LEXINGTON-FAYETTE URBAN COUNTY GOVERNMENT CONTRACT CHANGE ORDER Page 1 of 2		Date:	September 16, 2016	
		Project.	Fire Station #2 Replacement	
		Location	Lexington	
To (Contractor): Olympic Construction, ELC 216 Bromme Drive Nicholasville: KY: 40356		Contract No.	013-2016	
		Original Contract Amt	\$4,618,900.00	
		Cumulative Amount of Previous Change Orders	-\$1,379.24	
		Percent Change - Previous Change Orders		-0.03%
		Total Contract Amount Prior to this Change Order	\$4,617,520.76	
		Change Order No	4	
	You are hereby requested to comply with the following	ng changes from the contract pla	ns and specification:	
	Current Ch	ange Order	Medical Conference (Conference Conference Co	
ltem No	Description of changes-quantities, unit prices, chang in completion date, etc	Decrease in contract price	Increase in contract price	
n again an an an Arbanian 18 18	Reduce the height of of specific CMU walls per PR 06	5 \$4,649.8	3

Lexington Fire Station No. 2 Change Order #8 Proposal Request 6

Work Changes Proposal Request No. 6

13117 Lexington Replacement Fire Station No. 2

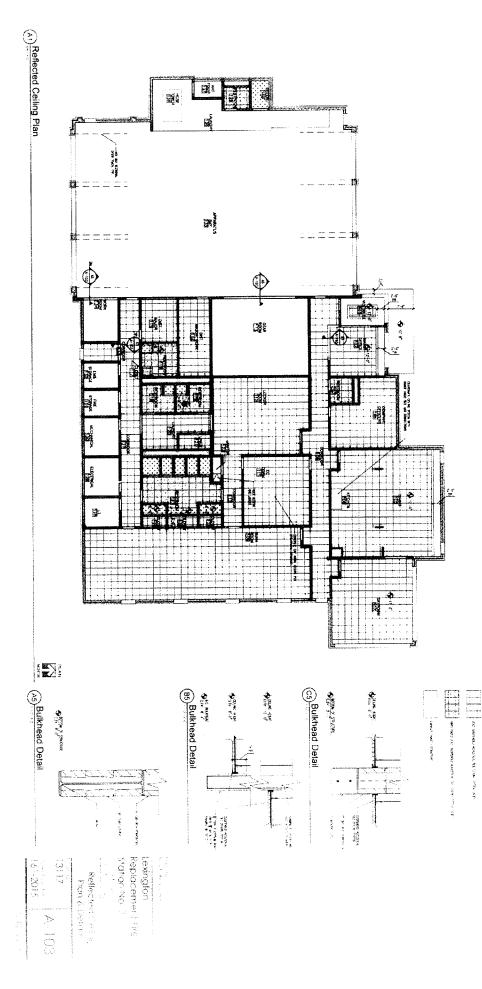
- 1. Per contractor request, see walls that are to be tight to deck above in the attached document. All other walls are to extend above ceiling by at least 1 CMU course or 12" for metal studs with bracing/kickers at 24" o.c. attached to deck above. Drywall should extend above ceiling a minimum of 6" or as shown in the documents.

- 2. Per unforeseen existing utility locations, where the depth is not sufficient. There is not the required storm depth available. There is only 14" between the gas and water line and since the soil strata below the water line is rock and the existing sewer main will interfere with the storm routing, see the modification of the storm sewer as shown in the attached. The gas line has been discussed with Columbia Gas and they are in process of a relocation design for their gas line that is in conflict. The storm and gas line relocation will need to be coordinated once the design for the gas is complete and available.
